DENVER RTD FASTRACKS

DRIVER MICROPHONE ASSEMBLY (DMA:GOOSENECK MIC)

TITLE: DRIVER MICROPHONE ASSY

DRG. NO: RES14002CT0 (MS) Ver. 00 Rev. -H RNE1002

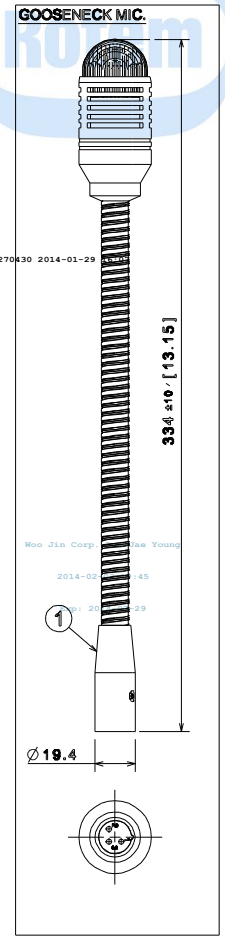
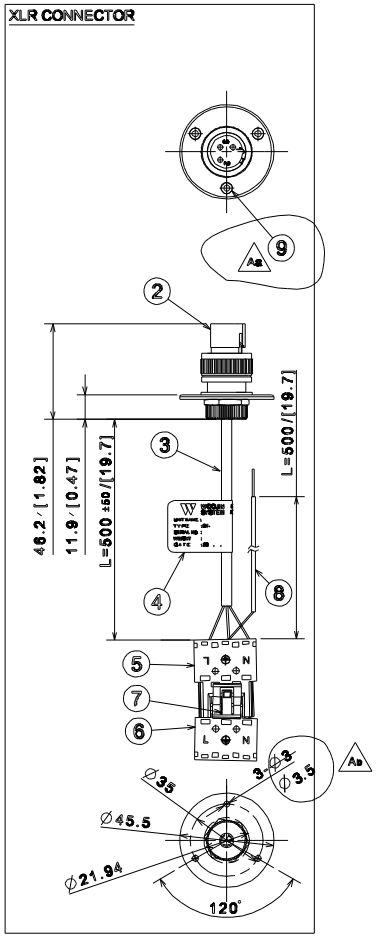
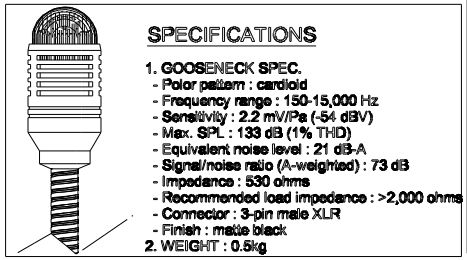
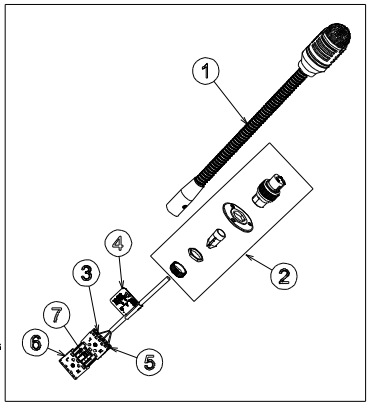
개정 CHANGE			
Redrawing. 2012.06.12	DGN	HY.SHIN	B.J.JONE
Rlvs. 9 added. 2012.12.05	DGN	HY.SHIN	B.J.JONE
Rlvs. 9 note changed. 2014.01.16	DGN	HY.SHIN	B.J.JONE

기호 MARK	일자 DATE	변경내역 DETAIL OF REVISION(E.C ZONE)	설변번호 E.C NO.	설계 DGN	검도 CHK	승인 APP
Hx1	2014.01.14	Changed the item No. 9 (#5 to #6).	RNE1002-U394	Y.S.JEON	C.Y.LEE	S.H.PARK
Gx1	2013.07.17	Added the limited fastening torque.	RNE1002-U345	Y.S.JEON	C.Y.LEE	S.H.PARK
Fx1	2012.12.05	The supplier added the item #9.	RNE1002-U144	Y.S.JEON	C.Y.LEE	S.H.PARK
Ex1	2012.03.15	The supplier revised the shape of Mic.		Y.S.JEON	C.Y.LEE	S.H.PARK
Dx1	2012.01.05	The supplier inserted connector spec.		Y.S.JEON	C.Y.LEE	S.H.PARK
Cx1	2011.12.29	The Connector is detailed		Y.S.JEON	C.Y.LEE	S.H.PARK
Bx1	2011.10.25	The supplier revised the drawing for FDR		Y.S.JEON	C.Y.LEE	S.H.PARK
Ax1	2011.08.10	The shape of MIC was changed by CUSTOMER		Y.S.JEON	C.Y.LEE	S.H.PARK

Note:Item #1 and #2 should be fastened within 0.8 kgf-m.(5.8 lbf-ft)
